East Coast Knitwear Pvt. Ltd. (Extension)

4 February 2024

Extension Building: Six (G+5) storied RC building with an underground water reservoir and fire pump room.

R=8 considered in the design report

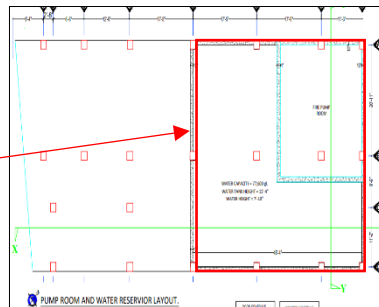
Description: Response modification factor $R=8$ has been considered in the design report. But no detailed calculation has been provided to support the consideration for the connection details. During inspection, the 50 mm expansion gap was observed in expansion joint. Calculations regarding building separation need to be included in design report in compliance with BNBC. The building engineer is required to provide necessary calculations to support $R=8$ and justify the provided expansion gap & submit the design report to RSC for further review.

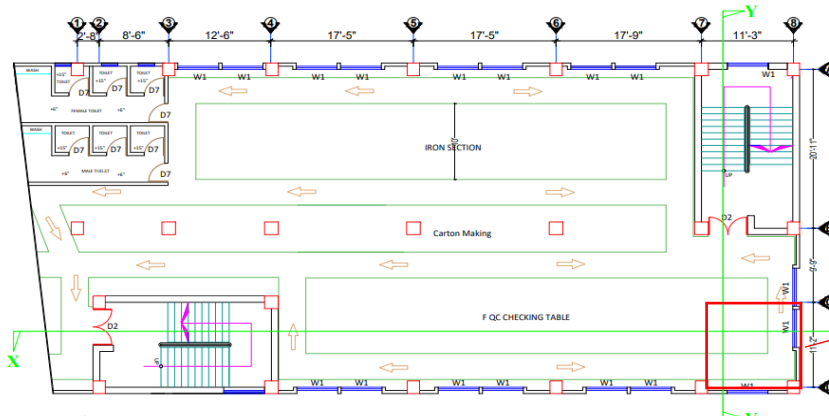
Description: Concrete compressive strength f'_c considered 4000 psi (27.5 MPa) in the design documents. The adequate number of concrete cylinder test reports were not available onsite as per BNBC. Additionally, two sets of cylinder test reports were available from the column, where the average result was not obtained. However, the individual strength of the cylinder does not meet the design strength at the age of more than 28 days for columns. The building engineer is required to verify in-situ material strength by taking four numbers of 100mm dia concrete core samples from lower tier of columns to justify the design strength.
